-
- (a) **Planning and Development Act 2000 (as amended) & Planning and Development Regulations 2001 (as amended) (Part 8)**
- (b) **Local Government Act 2001**
-

Modify the flood defence sea wall on James Larkin Road, D3 between Mount Prospect Avenue D3, and Watermill Road, D5.

The '***Sutton to Sandycove Cycleway & Footway Interim Works: Bull Wall to Causeway Road***' scheme was approved the City Council in 2012 (Report No. 3601/12). It has now been constructed.

Figure 1: Location Map: Shaded Area indicates extent of the Proposed Wall Lowering

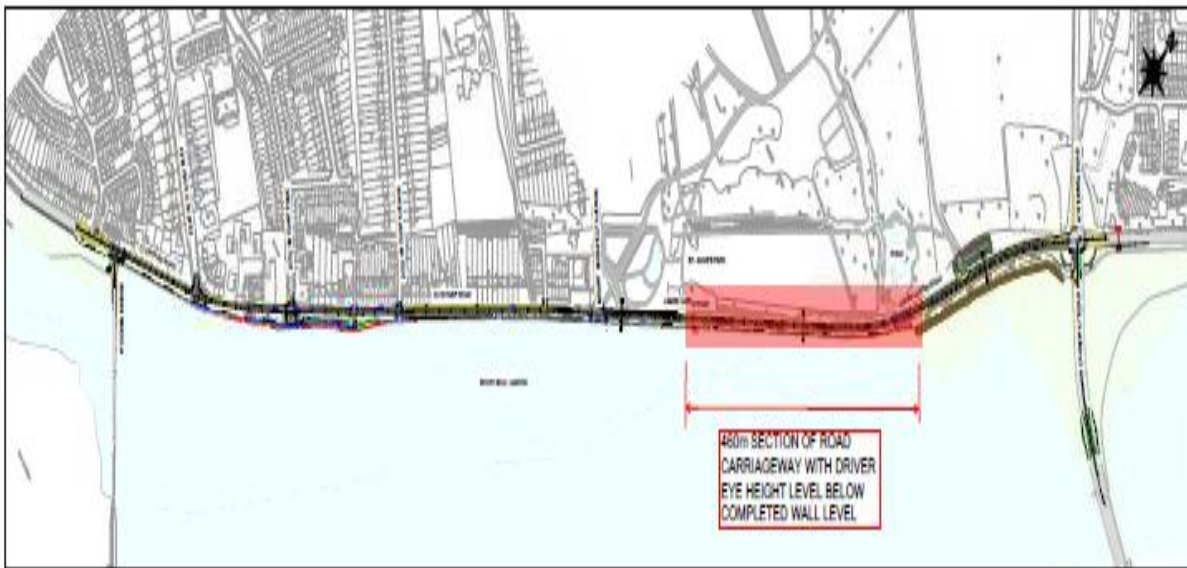
This group supported the proposed works and noted that ‘the works *‘will go some considerable way towards restoring the view.’*

Mr Dunne expressed strong opposition to the proposed works on the grounds that they would undermine the effectiveness of the sea wall as a flood defence barrier and that facing the wall in blue granite would be at odds with the existing seafront environment. He also questioned expenditure of significant monies *‘to carry out apparently frivolous works demanded by a small lobby group’*.

Mr Cronin welcomed the reduction of the sea wall. He also noted that to date there has been no flooding along this stretch from the sea.

Mr Wherity opposed the proposed works and referred to the *‘absolute waste of money taking down the wall’*.

Mr Ryan did not understand why the Council should be concerned with the view of motorists, as they should be looking at the road.

Reducing the height of the sea wall would be contrary to the recommendations of Dublin Coastal Flood Protection Project and will result in the sea wall not meeting the required level of flood defence specified in the national standard for flood defence schemes. In addition, there will also be a cost for raising the wall at some future date, in line with the recommendations of the independent expert. The reduction in the height of the sea wall will however provide a marginal improvement in sea views for motorists. On the basis of increased flood risk I cannot recommend the full Scheme to Members. I do however recommend that the proposed cladding be proceeded with, as this will enhance the visual appearance of the sea wall.

- (i) A reconstituted stone coping and limestone cladding of roadside face of the sea wall shall be constructed along the frontage of St Anne's Park. Any deviations from this shall be agreed with the Planning Department of Dublin City Council.
